Ref: 20100623-turbines  
Date: 23 June 2010

WIND TURBINE WAKE PLUME  
VELOCITY DEFICIT AND TURBULENCE

As per our latest telephone conversation I agreed to write a letter that you can present to the Victorian Review Panel handling the Stockyard Hill Wind Farm Application Number PL-SP/05/0548.

**Beaufort (Hawkwood)  
YBFT**

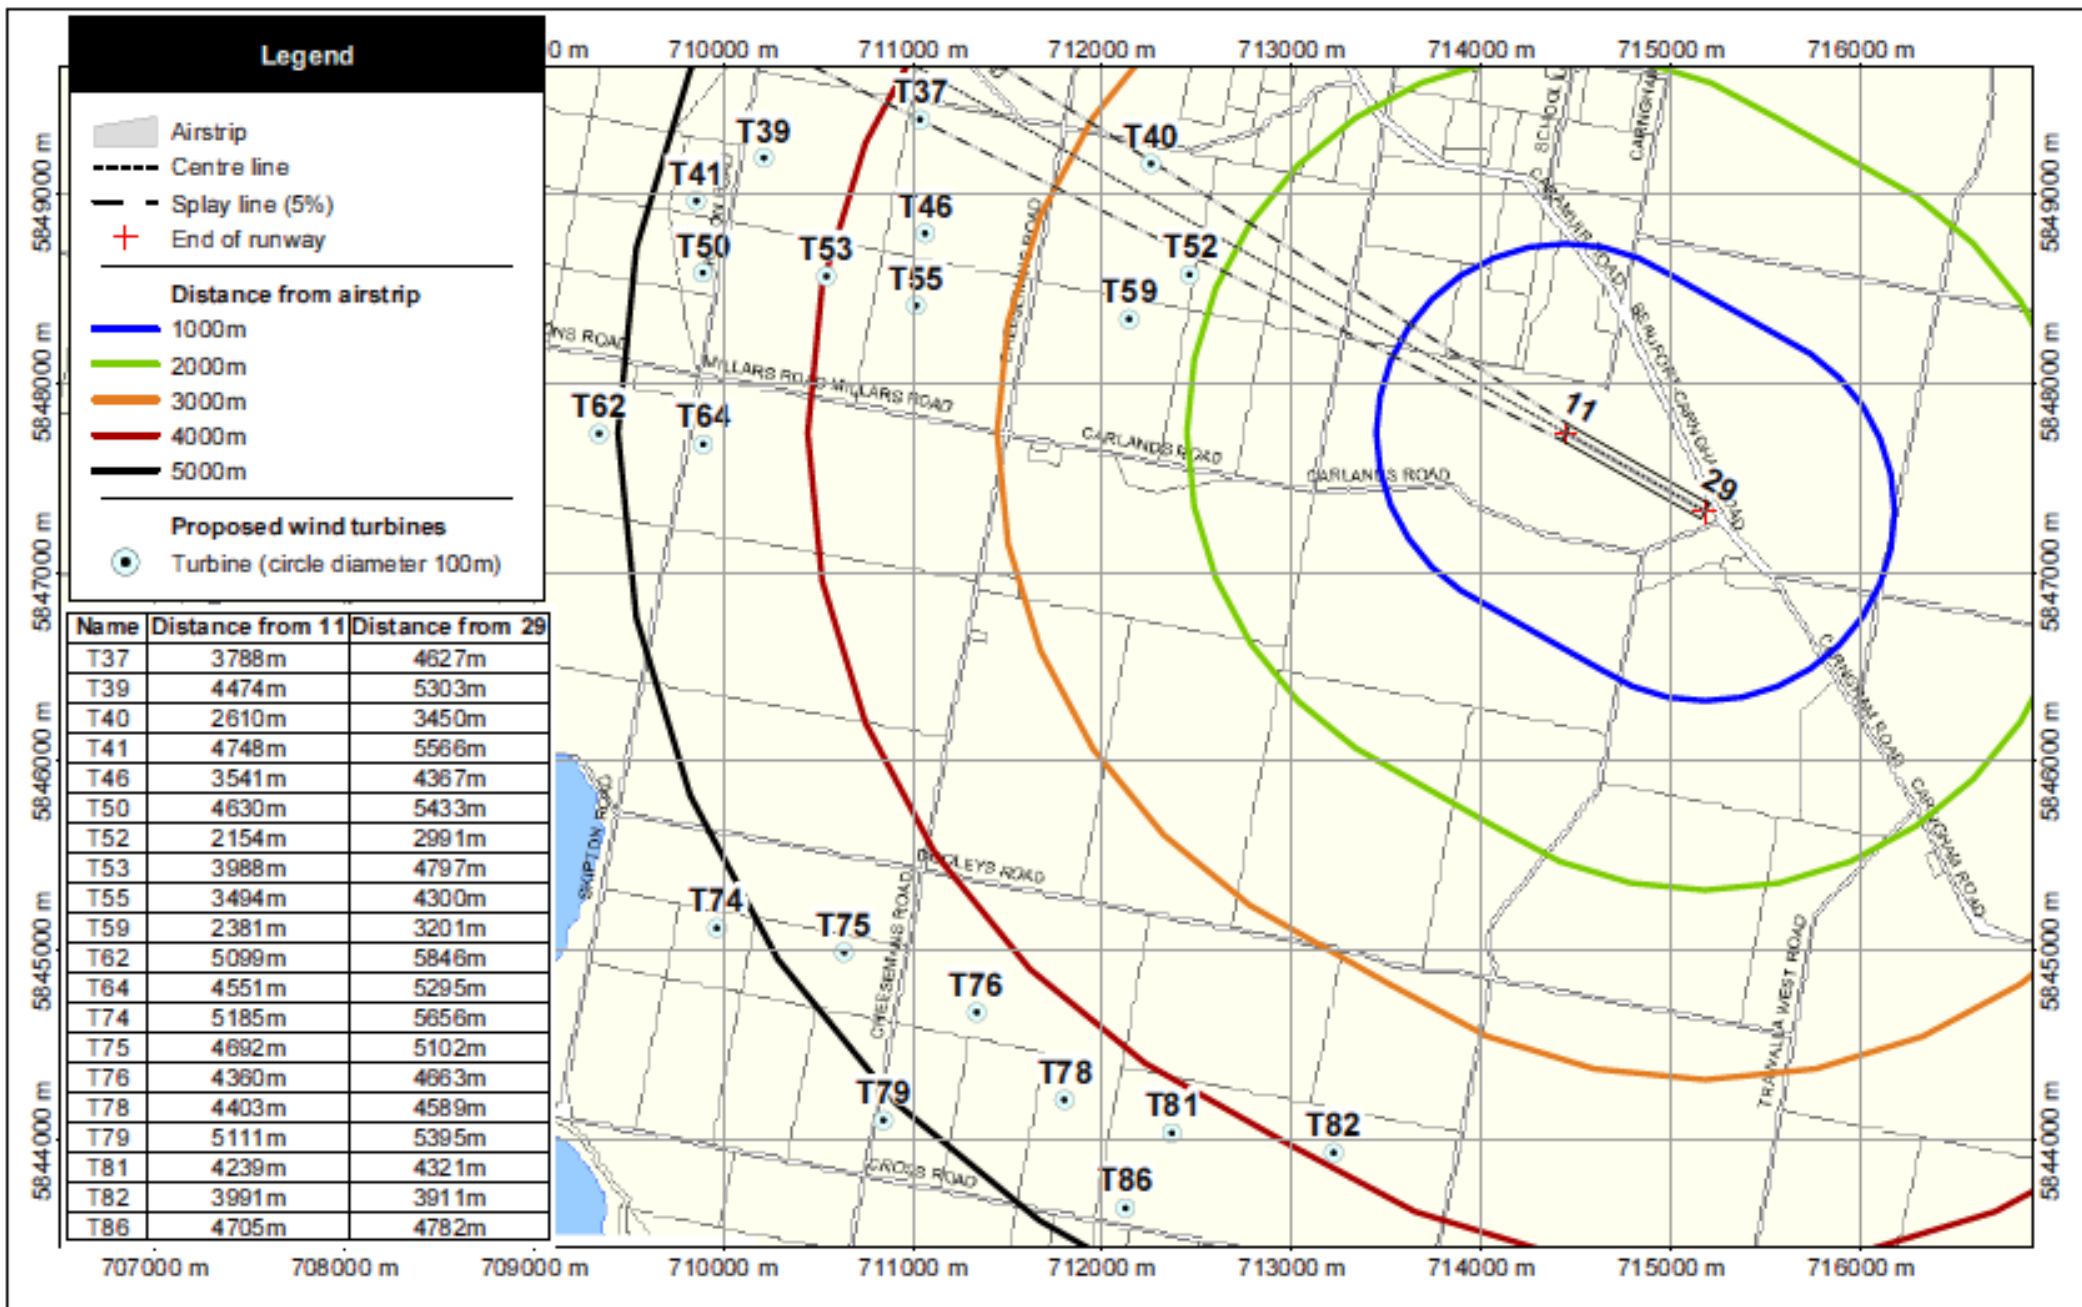
To assist with my analysis you provided me with a map detailing your ALA which included the location of the closest 20 turbines and distance arcs from your runway thresholds – which I will call the operational area map (Ref 8). This map is marked as Beaufort (Hawkwood) YBFT. I also sourced data from the Stockyard Hill Wind Farm Pty Limited website <http://www.stockyardhillwindfarm.com.au>, and it was determined that the proponent's submission involves turbines with a blade tip diameter of 104 metres.

With the information supplied from you that the strongest prevailing winds are typically from the North West, West and South West directions, and then surveying the turbine proposed locations on your operational area map, I can see two clusters of turbines that will directly affect your ALA operational area to varying degrees of extent, namely the clusters : T40, T52, T59, T37, T46, T55, T53, T39, T41, T50, T64 and T62 for direct take-off and landing, and clusters: T75, T76, T78, T81, T82, T74, T79 and T86 which will affect crosswind operations.

Thus I would argue for an operational area of 4920 meter radius from the runway threshold for Category B aircraft and a setback of turbines from this operational area of 50 blade diameters. This represents an additional 5200 meters for turbines with the proposed 104 metres blade-tip diameter.

I wish this to be put to the panel, and to the proponent, that a comprehensive study be conducted under duty of care before allowing any turbines within the setback distance of 50 blade-diameters from the Category A or Category B circling area radius as deemed appropriate for the airport use. I recommend that such a study be reviewed by parties independent to the proponent's witness, and to be operated under the Review Panel's instructions.
